Use of rear half of site for coach/bus depot for 64 buses/coaches and 38 mini buses with associated, plant storage facility, ancillary office and associated landscaping and formation of access from Walthamstow Avenue roundabout.

Car Park opposite Dog Stadium, 457 Chingford Road Chingford, E4

Project	NE Thames Area Evaluation of Models and Flood Risk: 2 - Car Park Opposite Dog Stadium 457 Chingford Road Chingford, E4	Project No.	2011s5185
Subject of Review	ISIS-TUFLOW hydraulic model		
Revision	1	Date	30/09/11
Project Manager	Francesca Hurt	Reviewer	Alistair Clark
Documents used in Review	The control files and model layers have been provided for modelled scenario. 2D model check files, 1D and 2D model results have been provided for all scenarios. Technical Report – Overview of hydraulic modelling		
Applicable Standards or Guidance	TUFLOW User Manual 2008 – BMTWBM 1D-2D Model QA Training - Model Audit Proforma – JBA Living Draft		
Purpose of Study	Flood Risk Assessment (FRA) for redevelopment of former car park at Walthamstow Stadium to new bus park, which includes new office building, bus wash facility, fuel tank, store and plant room. Site is partly located in Flood Zone 3

Figure 1: 1D ISIS Diagnostic Plot

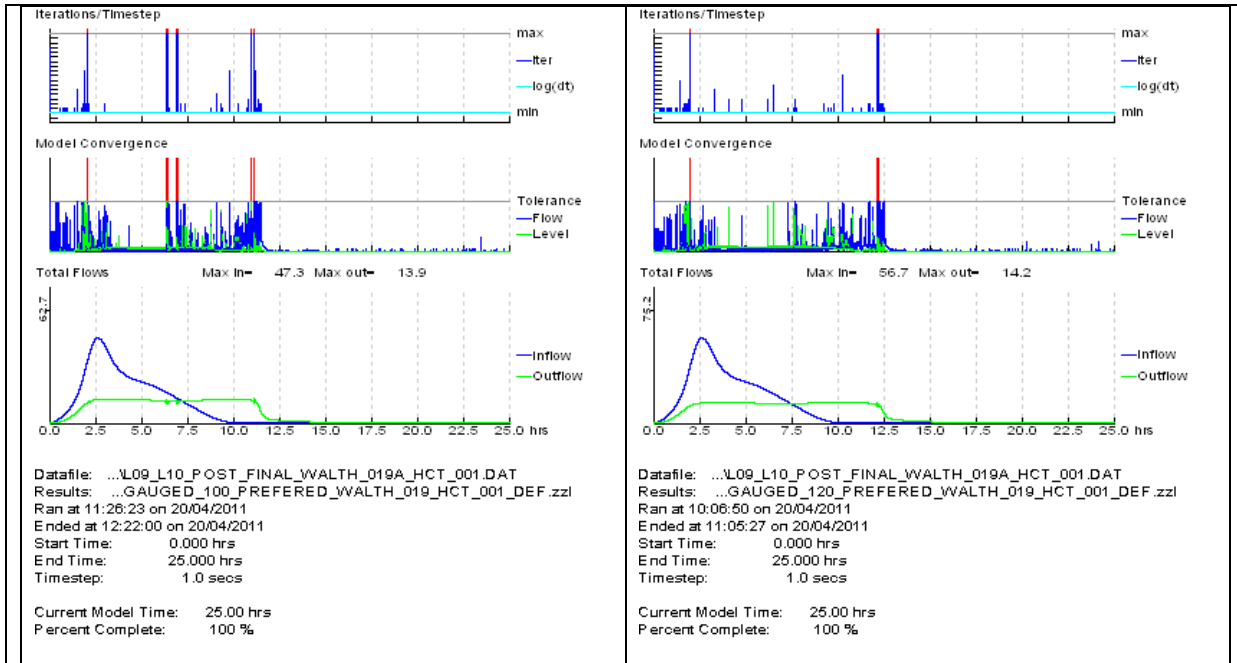
7-1 This section has been assessed using the 100YR and 100yr20 event results provided. The 1D model results for the 100YR run show that the model is relatively stable (Figure 1). The 100yr20 event model shows that the model is more stable during the falling limb of the flood hydrograph.

Figure 2 dVol plots for model scenarios

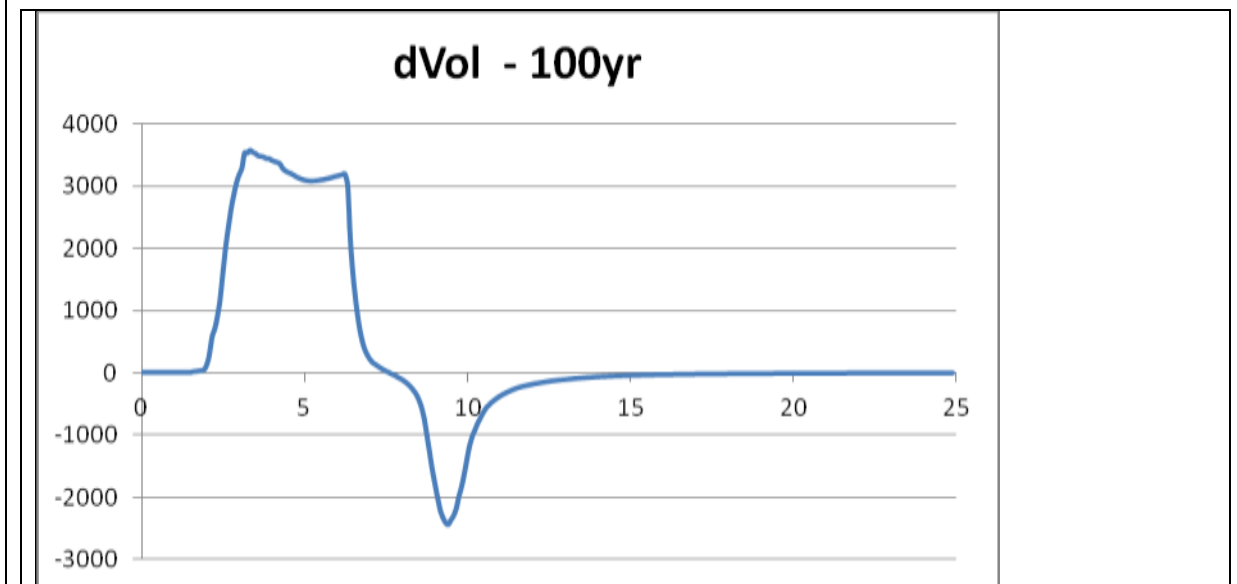
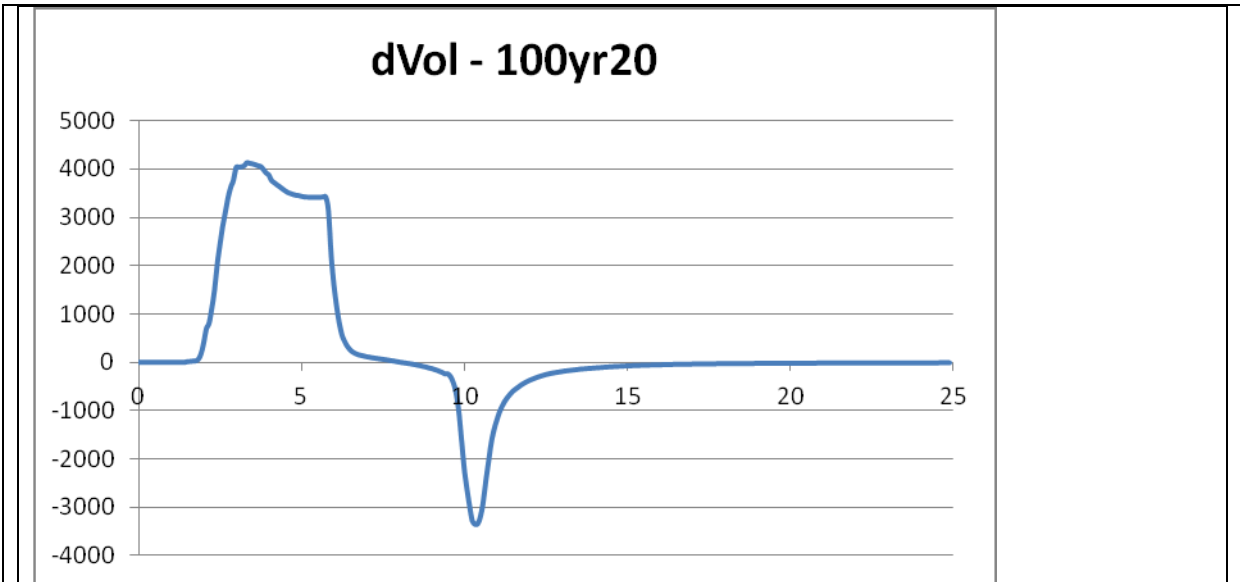
7-2 The dVol output from TUFLOW (Figure 3) representing the change in volume in the 2D domain is a good indicator of model stability and should be a smooth transition from one timestep to the next. Figure 3 shows that there is a smooth transition throughout the model run suggesting that the model is suitably stable.

Figure 3 Cum ME (%) plots for model scenarios

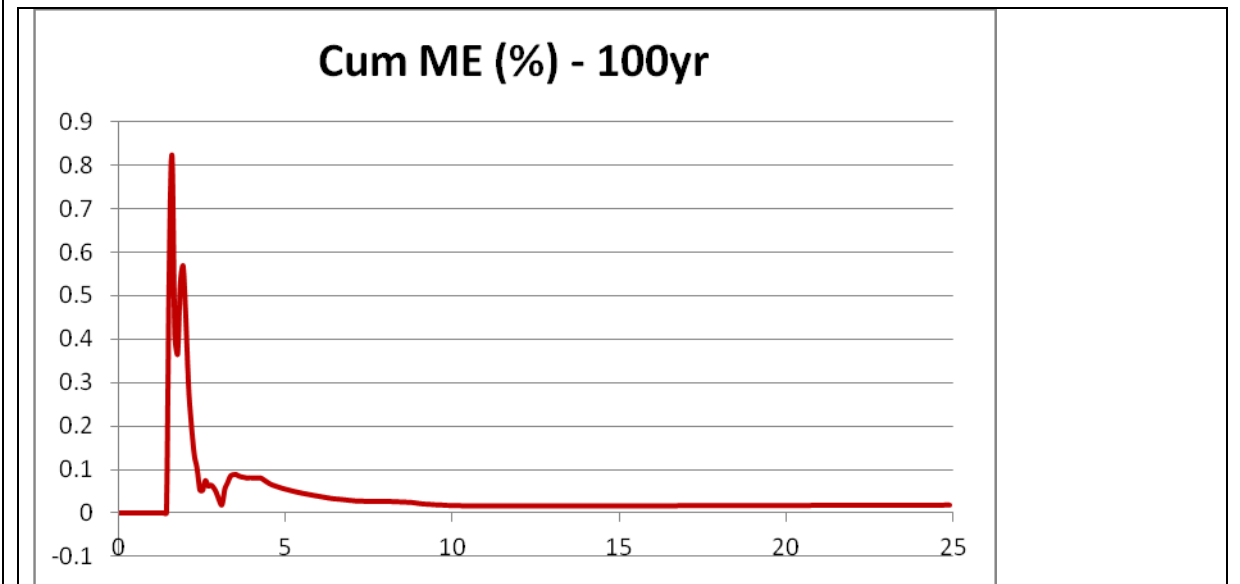
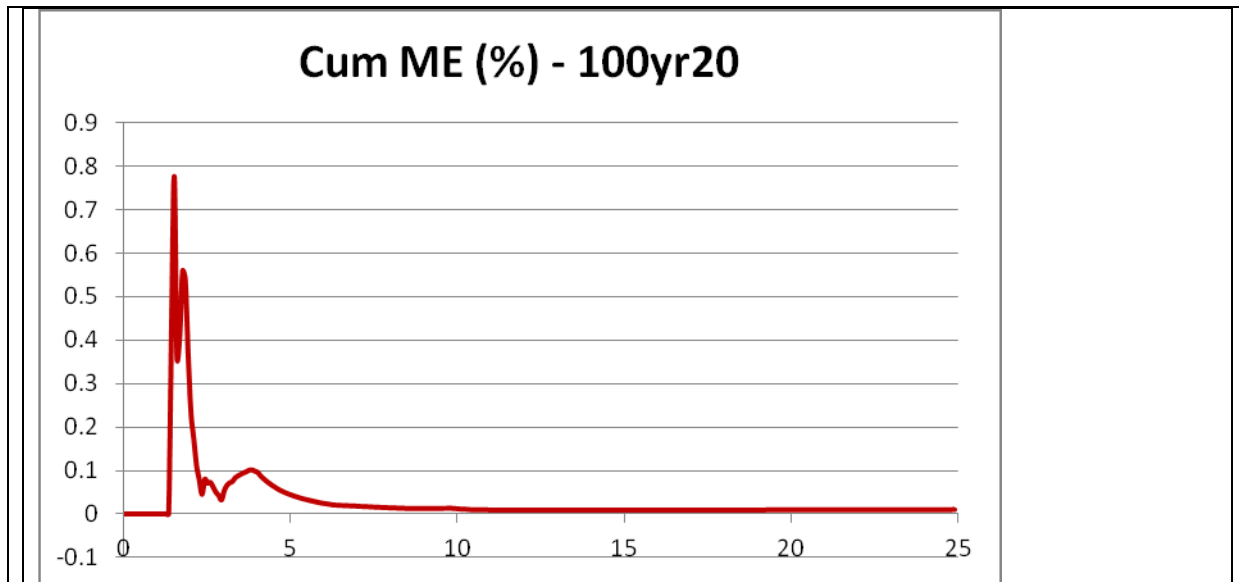
7-3 Checks have been made on the mass balance outputs for the model runs. These give a good indication of model stability and accuracy. Figure 4 show the mass balance errors (CUM ME) for the 100yr and 100yr20 event model runs. Both runs remain within the range of +/- 1%, which is normal for a healthy model.
